**COUNTY OF SAN MATEO
PLANNING AND BUILDING DEPARTMENT**

SUBJECT: EXECUTIVE SUMMARY: Consideration of a Coastal Development Permit to install and restore a low-profile landscape planter to an existing gas station located at 9400 Cabrillo Highway in the unincorporated Moss Beach area of San Mateo County. The project is appealable to the California Coastal Commission.

County File Number: PLN 2017-00199 (KN Properties)

SHEET
 C-1

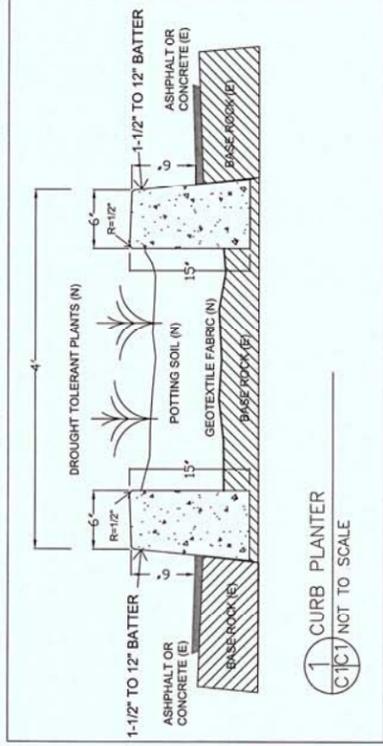
MCC requests planter extension to Vermont, minimum 4-ft planter width, and reduced highway access from 144 to 60 ft.

3 x 34 ft planter proposed to replace 13x63 ft planter removed w/o permits.

Proposed Curb Planter Detail Section 3 feet wide, 6 inches high

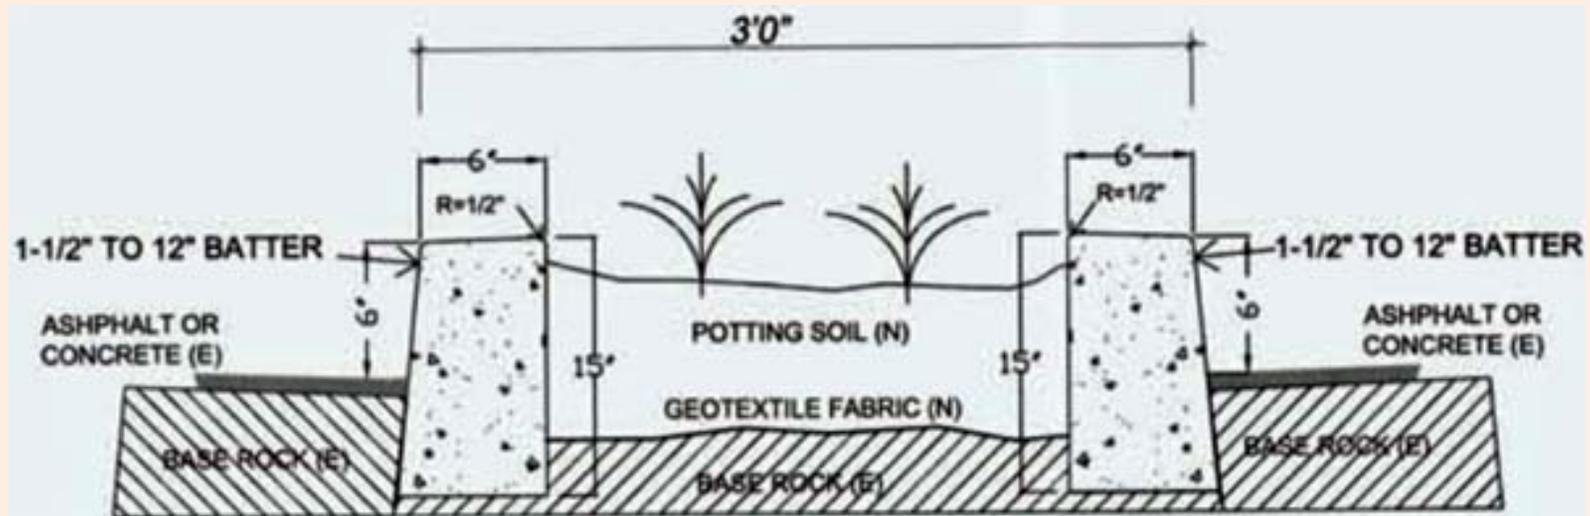
Curb (6" HxW) occupies one third of planter width.

No matter how drought tolerant, plant viability will be poor in this extremely limited soil volume.
